REVISION E

ERF8 ASSEMBLY

ASP-148421-01

RECOMMENDED PCB LAYOUT

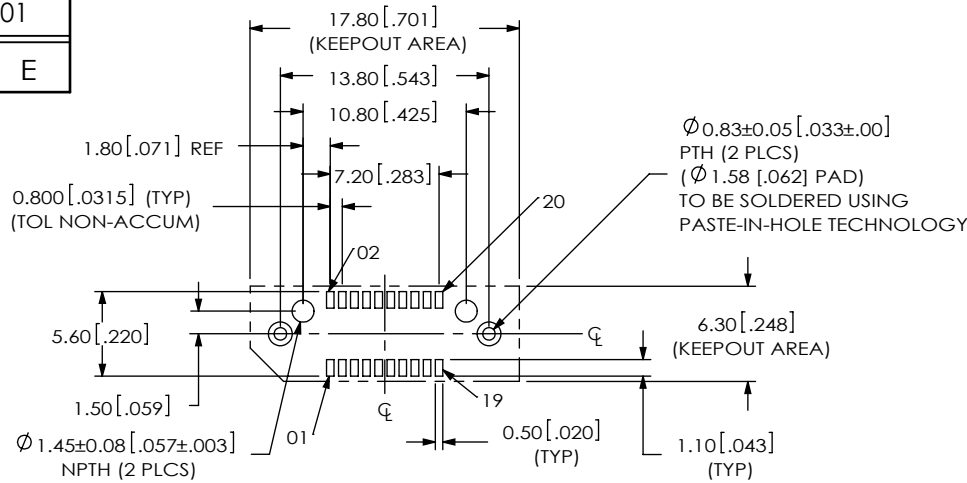
SHT 2, RECOMMENDED PCB LAYOUT: DEL 5.30 (TYP), ADD 1.80 REF. CHG 5.61 TO 5.60, CHG Ø0.83±0.02 TO Ø0.83±0.05, ADD NOTE TO BE SOLDERED USING PASTE-IN-HOLE TECHNOLOGY, RECOMMENDED STENCIL LAYOUT: CHG 16.20 TO 13.80, CHG Ø1.58(2 PLCS) TO Ø2.24(2 PLCS).
